S-0031-2017,234 Neck O'Land Subdivision

Re: Minor Subdivision of 234 Neck-O-Land Road (Development Plans)

James City County plan S-0031-2017

STORMWATER & RESOURCE PROTECTION DIVISION REVIEW COMMENTS 234 Neck O'Land Subdivision COUNTY PLAN NO. S-031-17

COVER SHEET

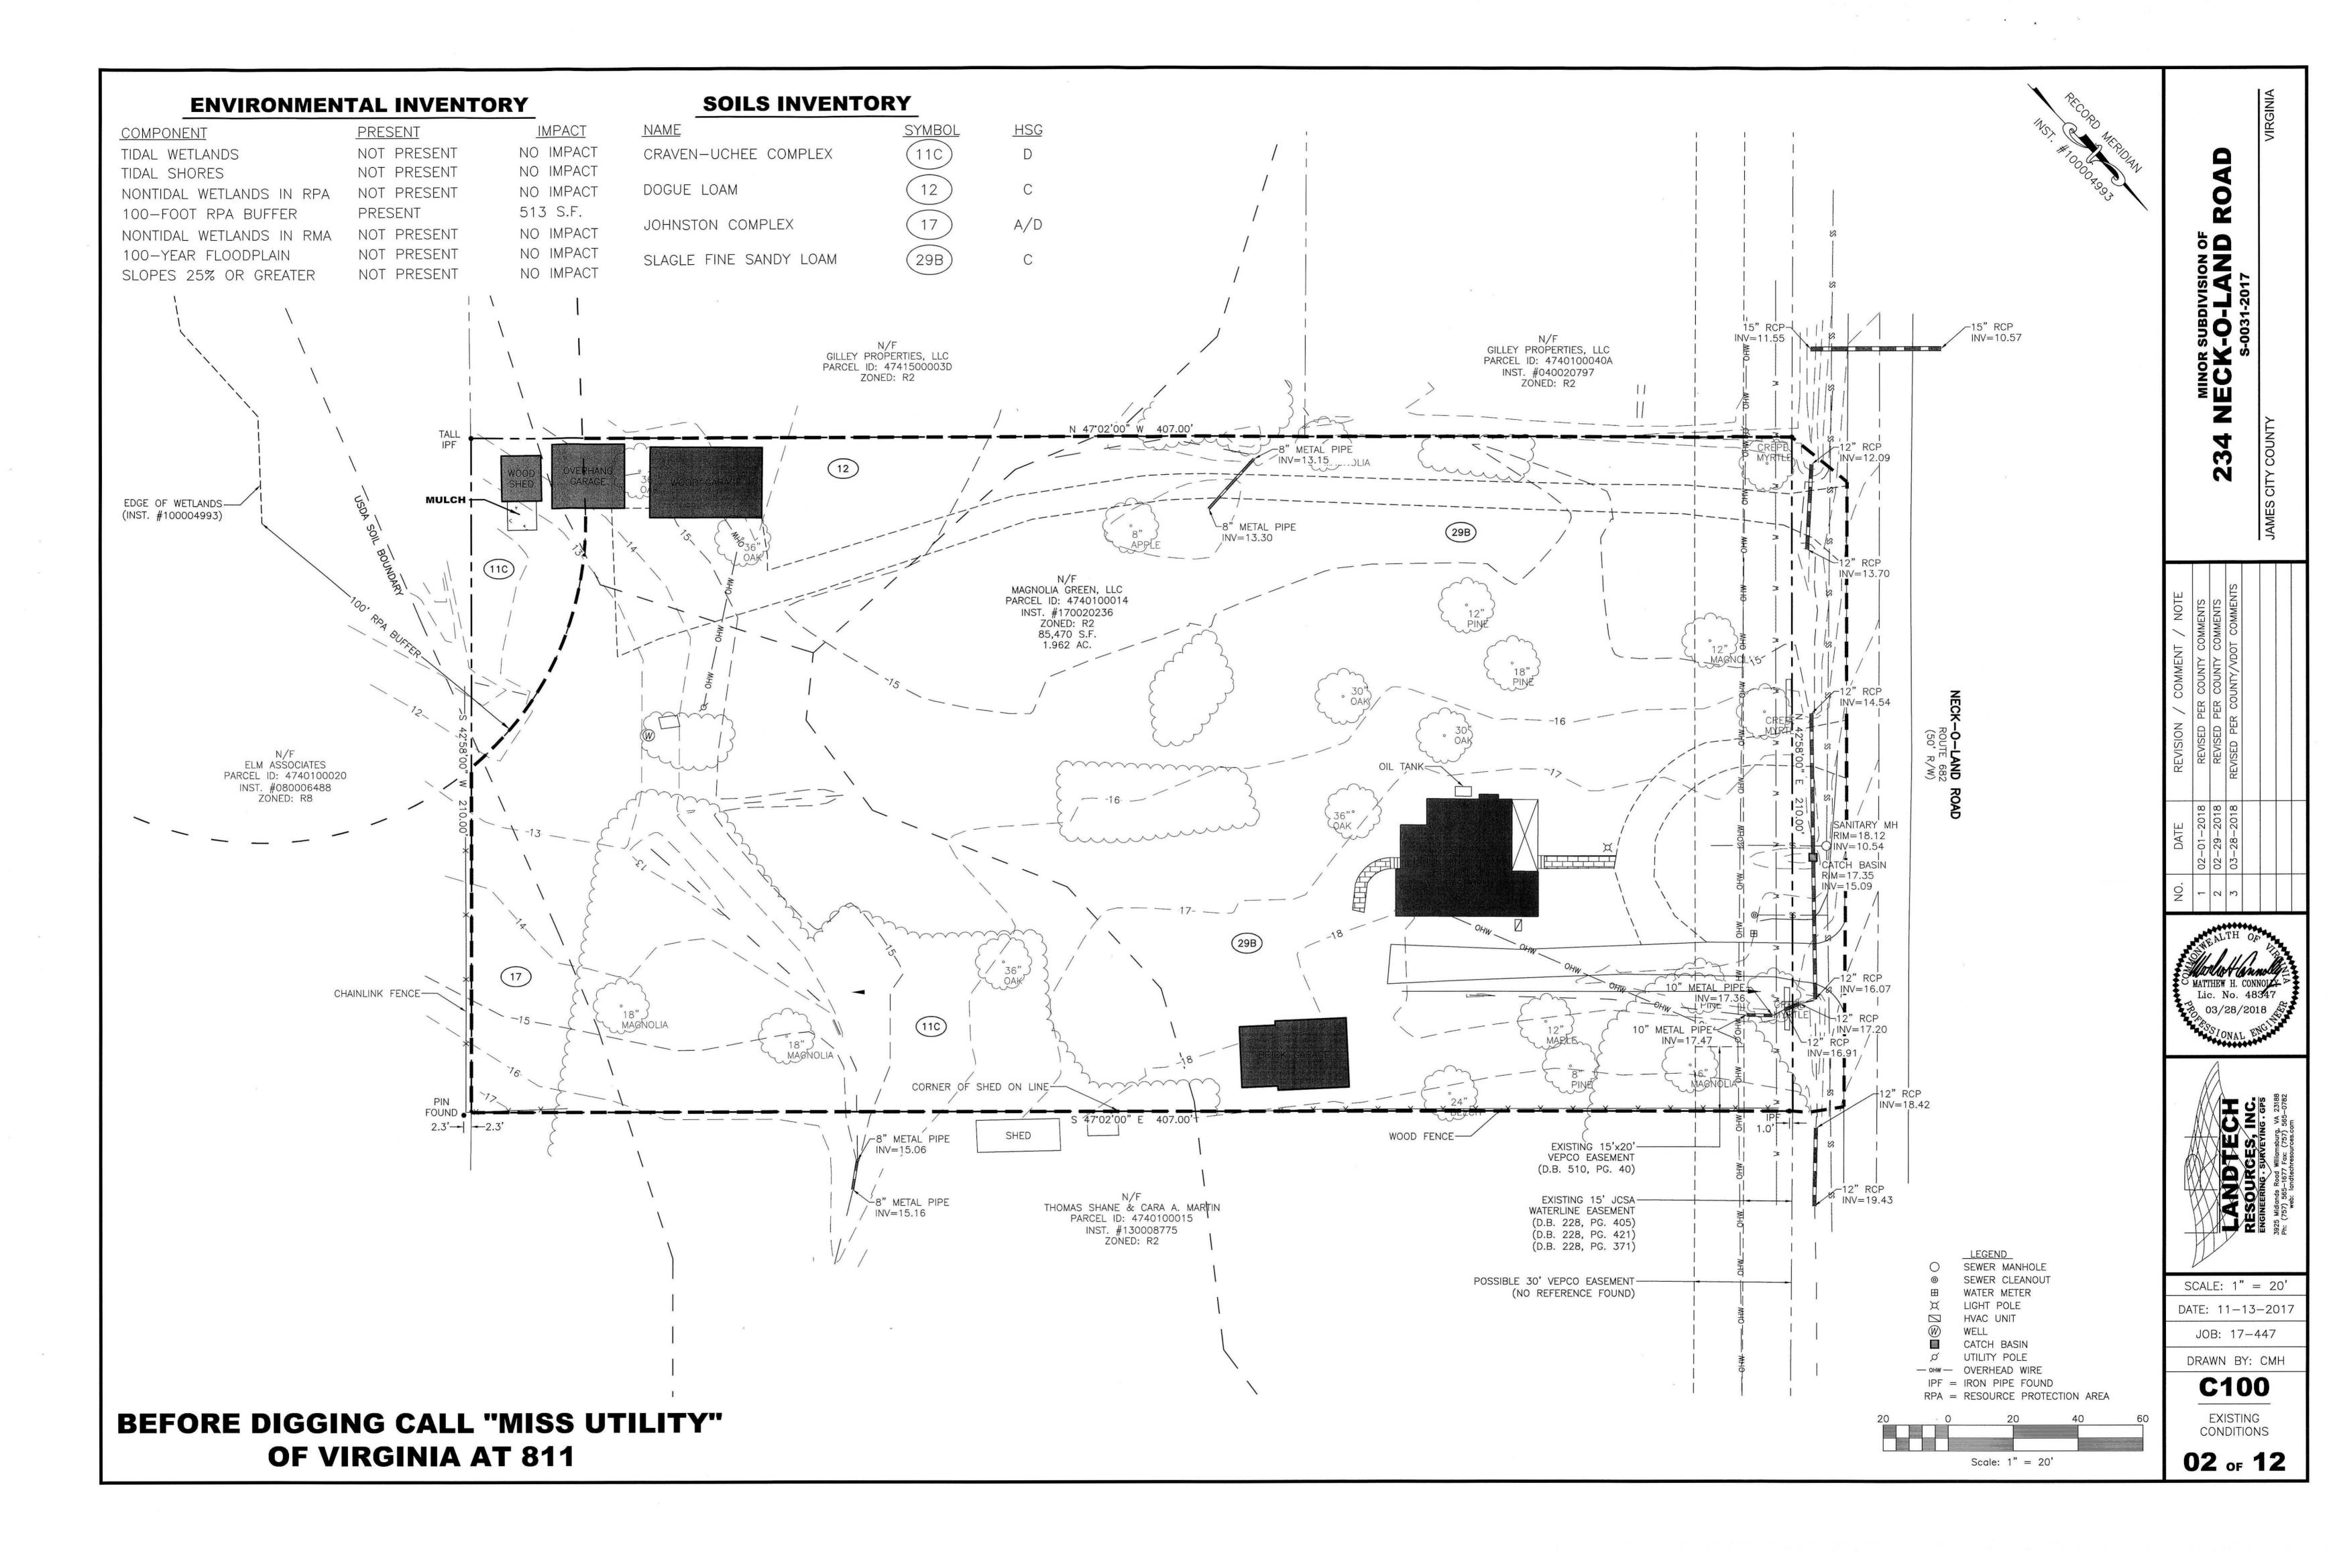
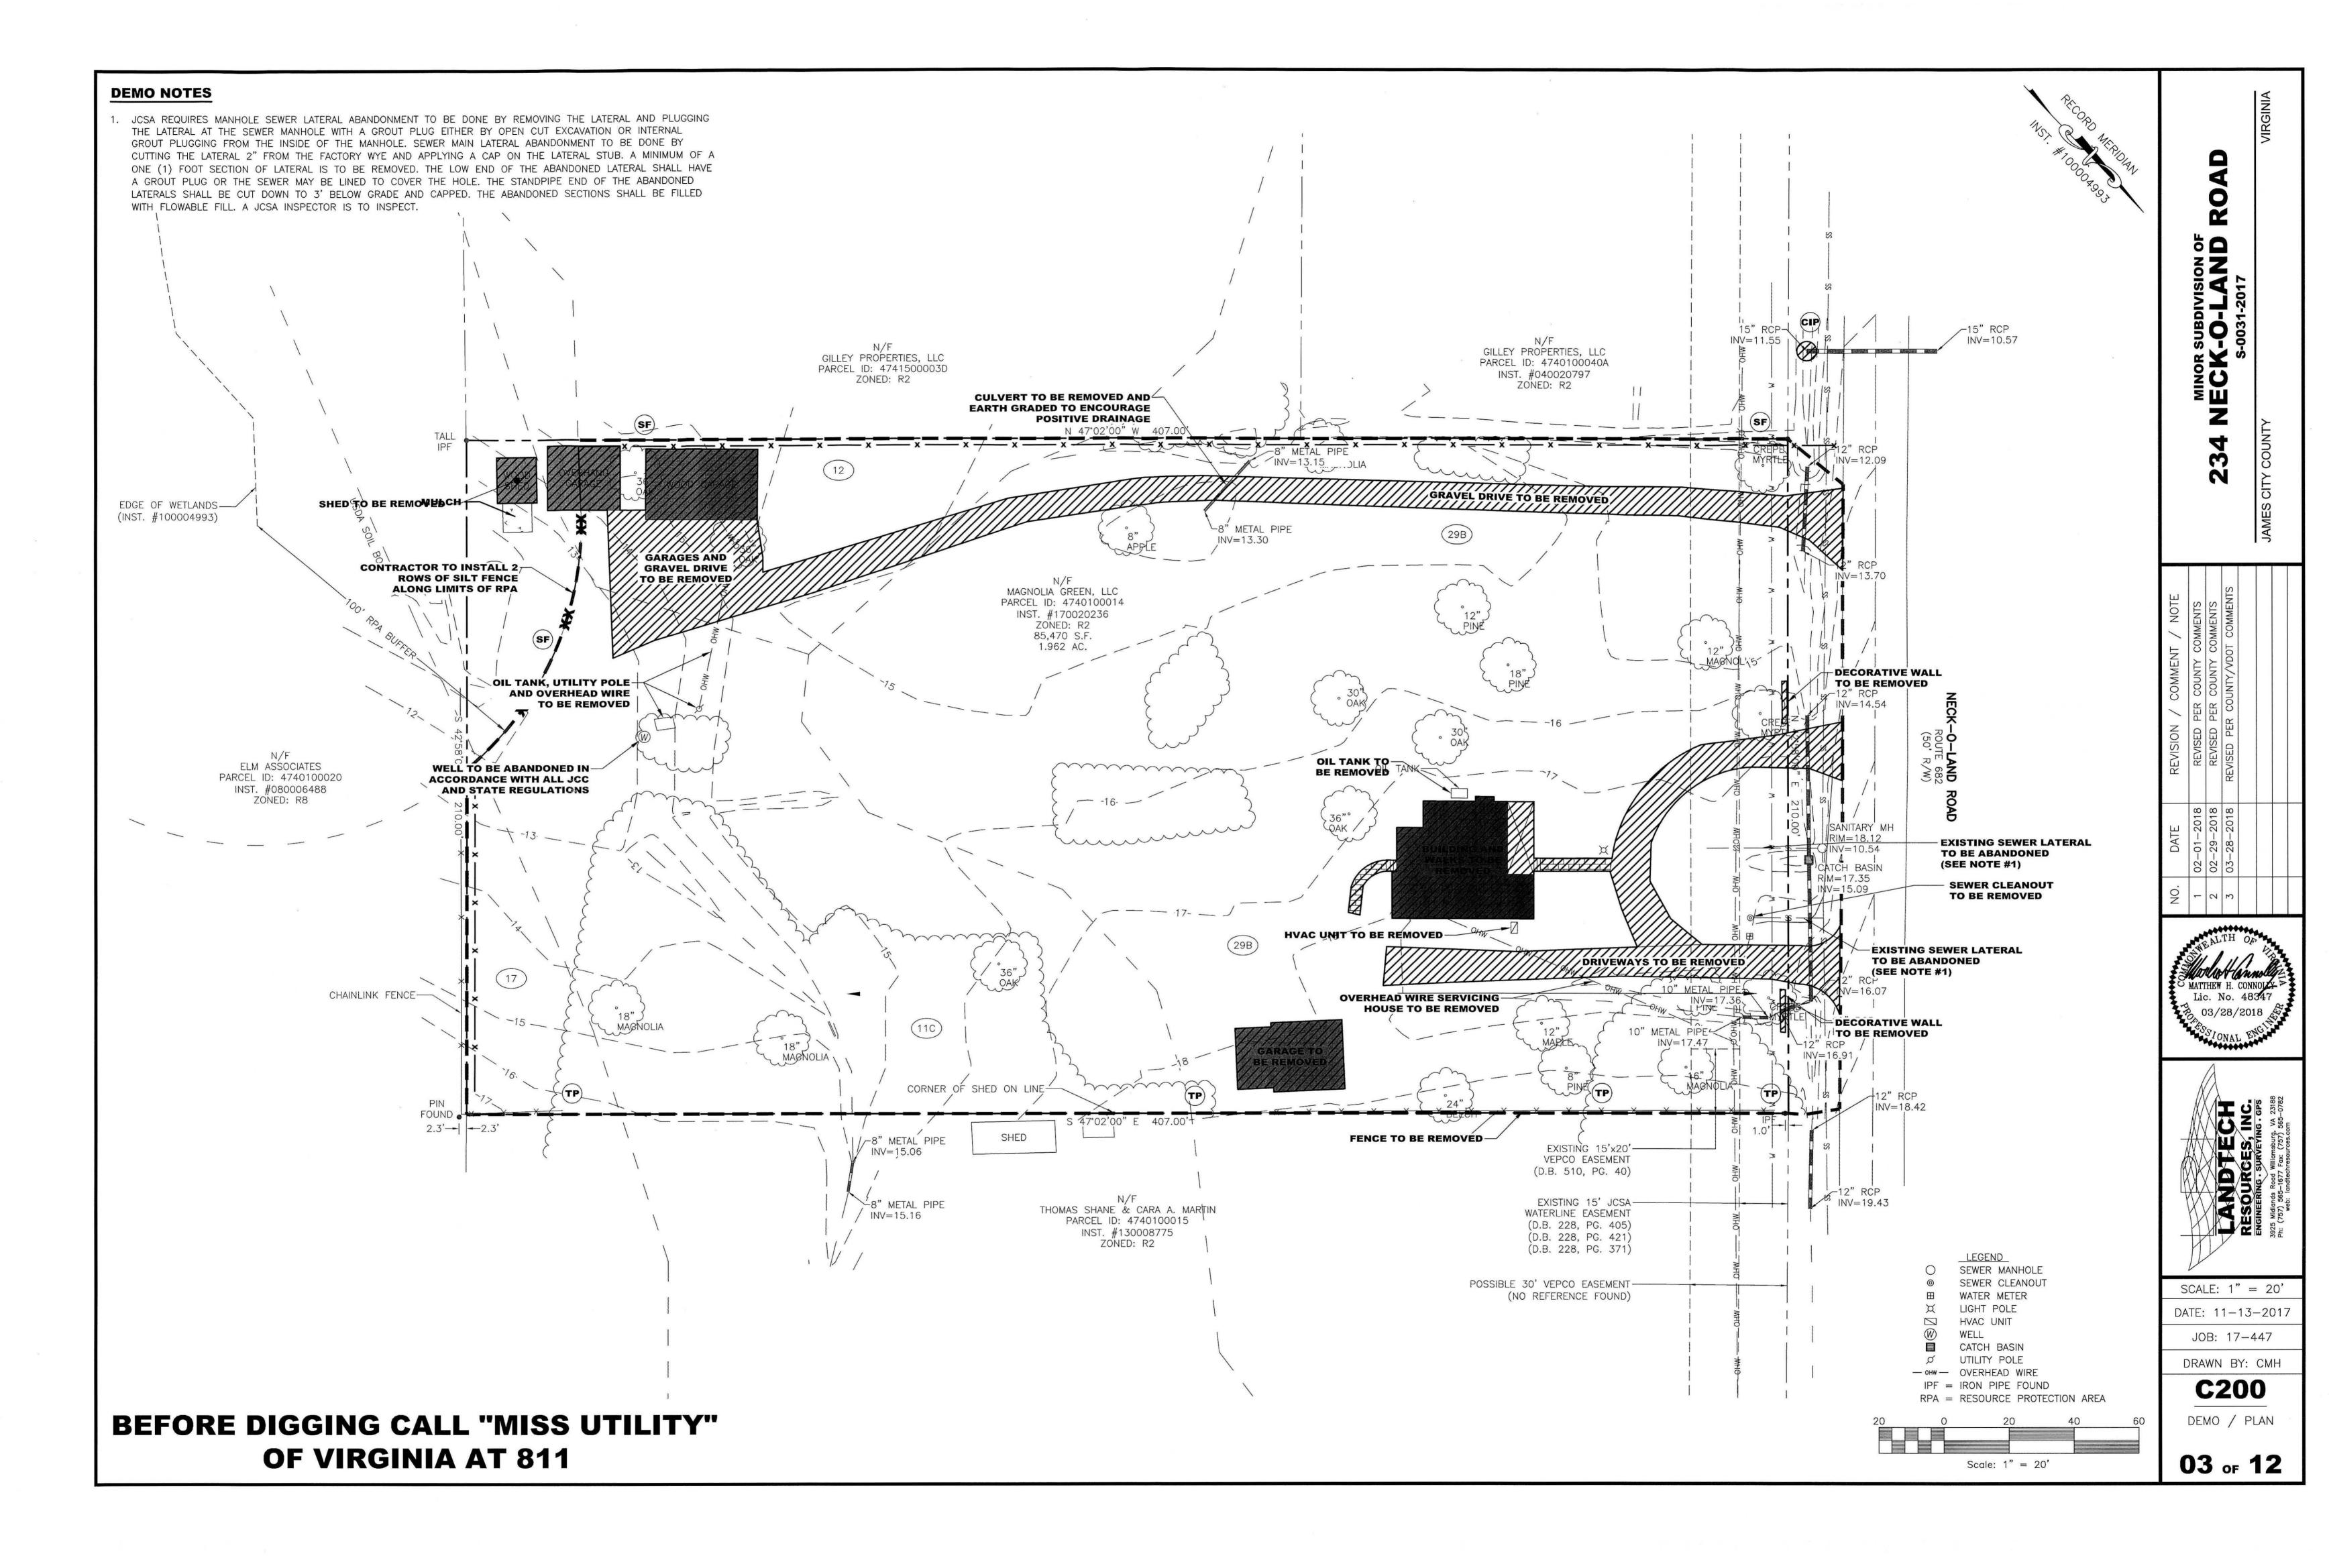
- 1. Sediment Trap. The proposed sediment trap needs to be installed at the Phase I as part of the preliminary E&S Control measures. Review.
- 2. Proposed Ditches. The proposed ditches not in connection with the sediment trap should have a riprap and stone barrier similar to the one in the trap spillway to control sediment laden from leaving the site. Consider isolating the ditch that runs toward the RPA entirely, since offsite runoff will be also added to it.

- 5. Proposed Ditches. The temporary check dams shown on sheet C400 should be installed on the Phase I of the Erosion and Sediment Control plan. Ensure this is included on the construction sequence as well. Please review.

1. A sediment trap has been added to C201

- 2. Swales have been relocated to run along the property lines. Easements have been added over top of drainage swales.
- 3. The level spreader is not designed in accordance with VA DEQ Stormwater Design Spec #2. The intent is just to spread out concentrated flows.
- 4. This area has been revised.
- 5. An easement have been provided on the diversion swales along the edge of the property to benefit the northern parcels.
- 6. Two (2) sets of calculations have been included with this submission showing compliance.
- 7. Water Quantity Drainage Maps with appropriate calculations have been provided at the end of the plan set.
- 8. Sections of the open channels have been provided on DA101
